Vermont Agency of Transportation
RECEIVED
Jamaica ER-BRF 013-1 (23) - RSS Resub 4-16-2013.pdf

RESUBMIT YES Rejected
BY KMH DATE 04/16/13

Project: BRIDGE REP-CHANNEL WORK ER JAMAICA

Drawing: ABUMENT "1" REINF

ABUTMENT #1 PLAN

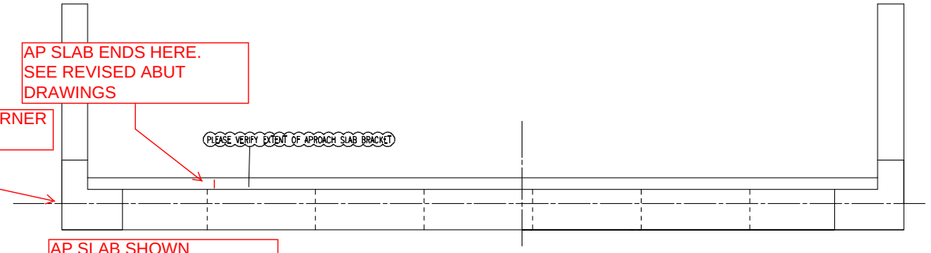
AP SLAB ENDS HERE. SEE REVISED ABUT DRAWINGS

PLEASE PROVIDE CORNER DETAIL

ABUTMENT #1 ELEVATION

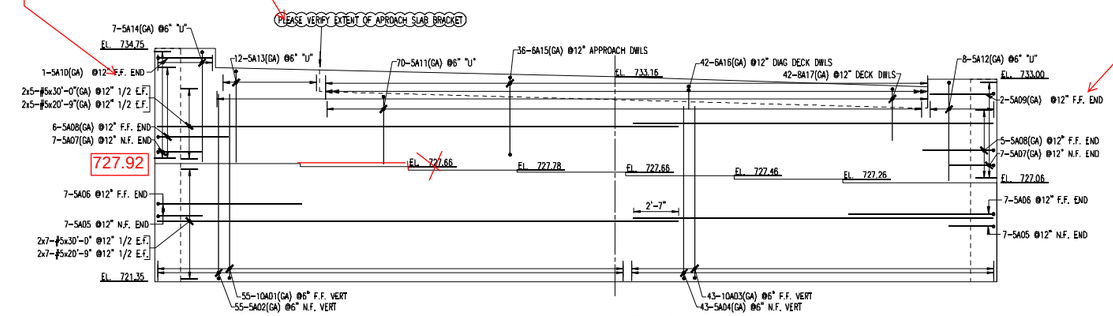
AP SLAB SHOWN CORRECT IN THIS VIEW

WINGWALL #1 ELEVATION

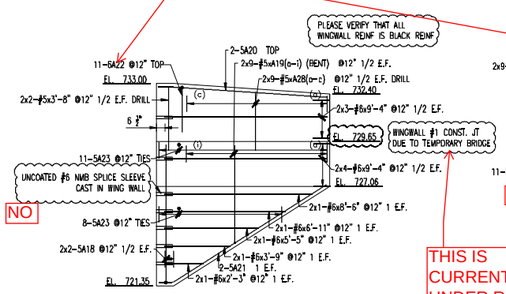
THIS IS CURRENTLY UNDER REVIEW

ABUTMENT 2 ELEVATION

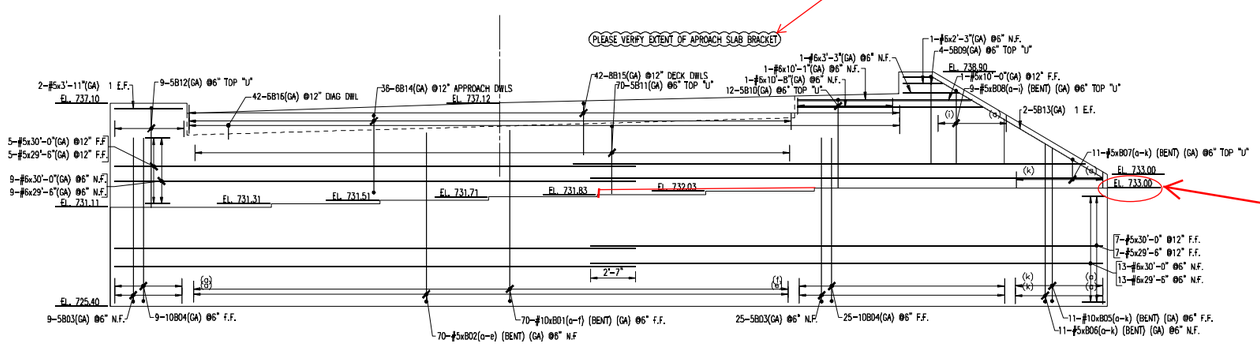
EL 731.97
SEE ATTACHED REVISED ABUT
DRAWINGS

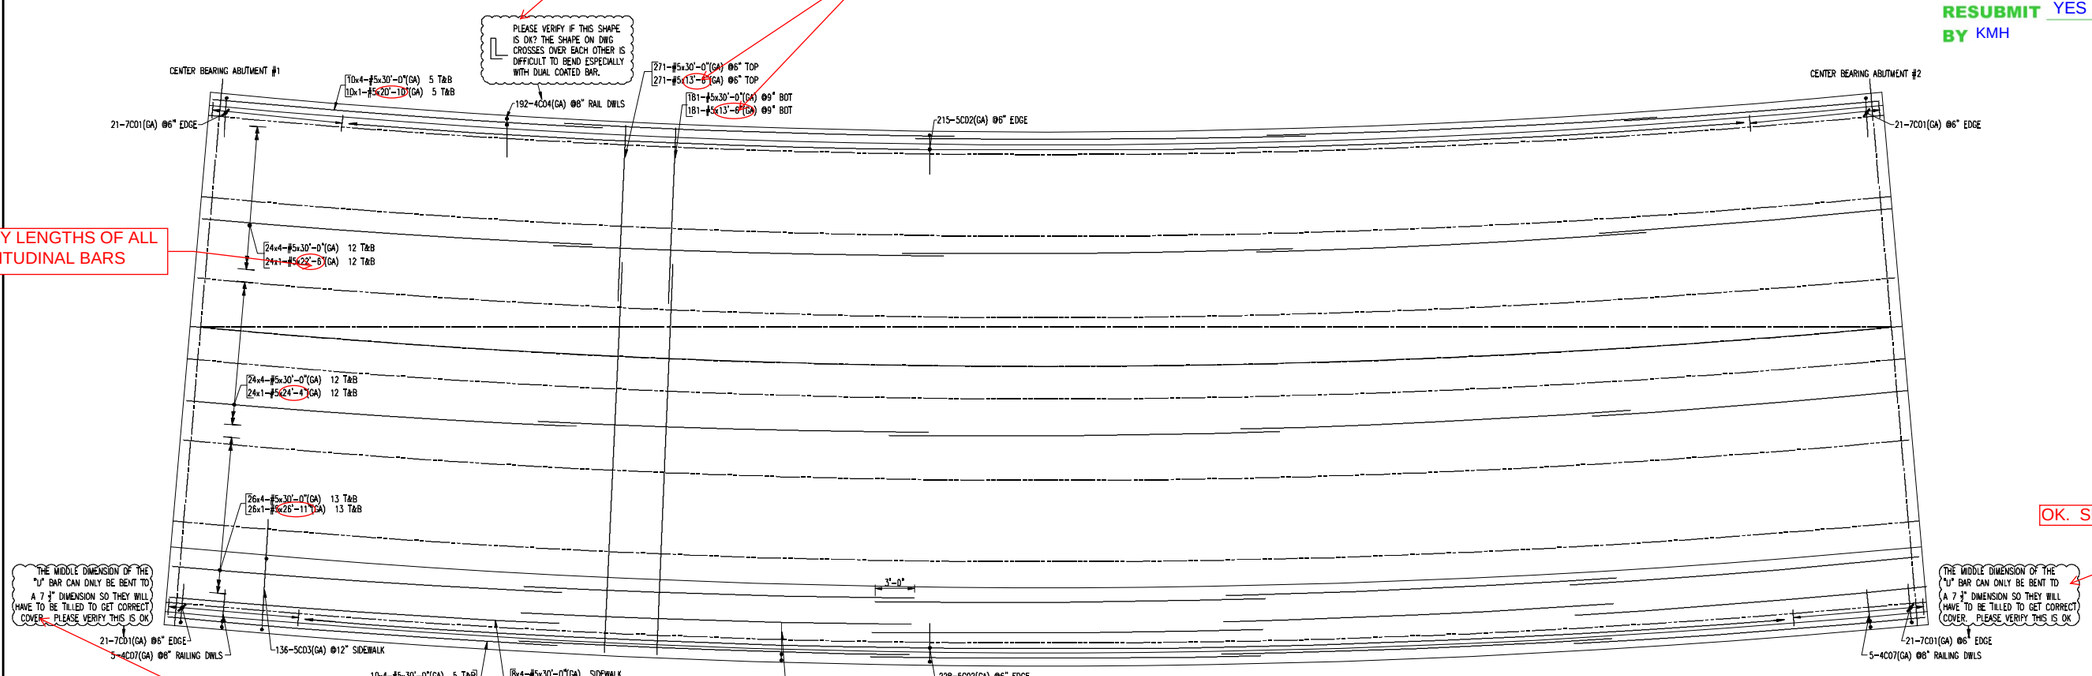
VERIFY LENGTHS OF ALL LONGITUDINAL BARS

OK. ADD NOTE STATING BARS WILL NEED TO BE TILTED UNTIL CLEAR IS MET

OK, SEE COMMENT ON NEXT SHEET

ABUTMENT 1 PLAN

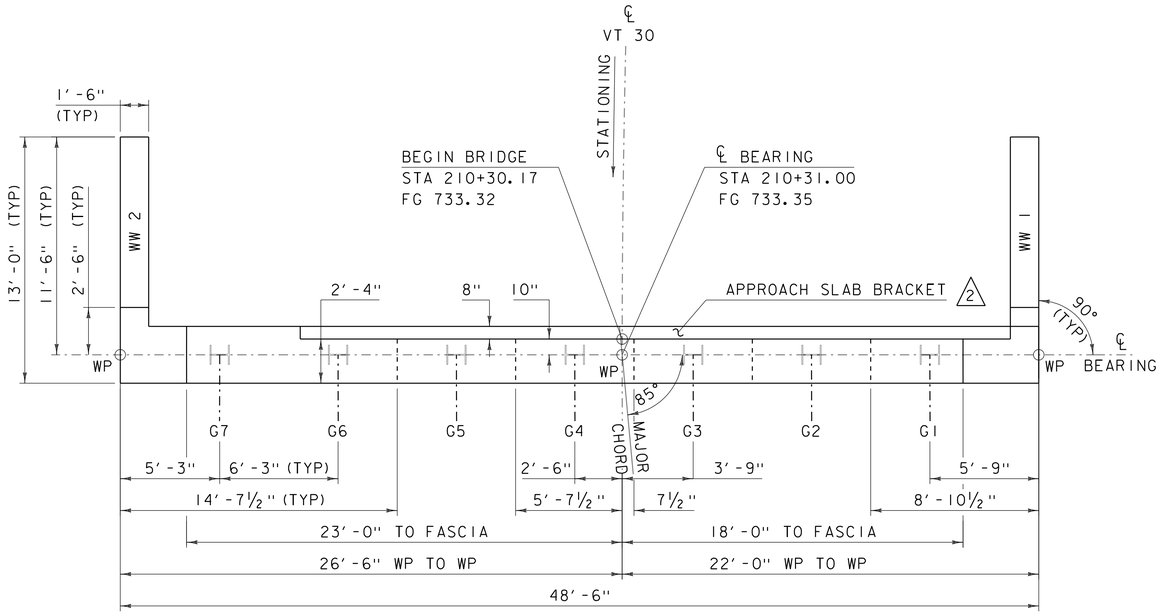
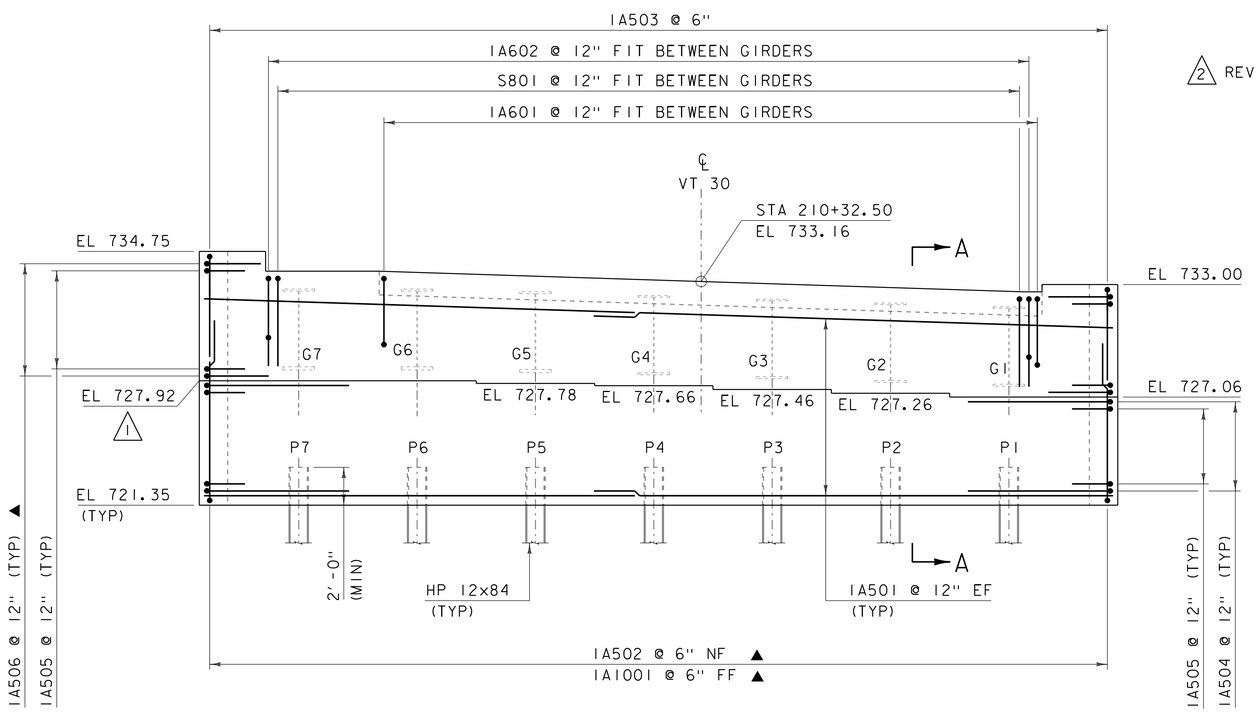
- REVISED APPROACH SLAB BRACKET WIDTH IN PLAN VIEW
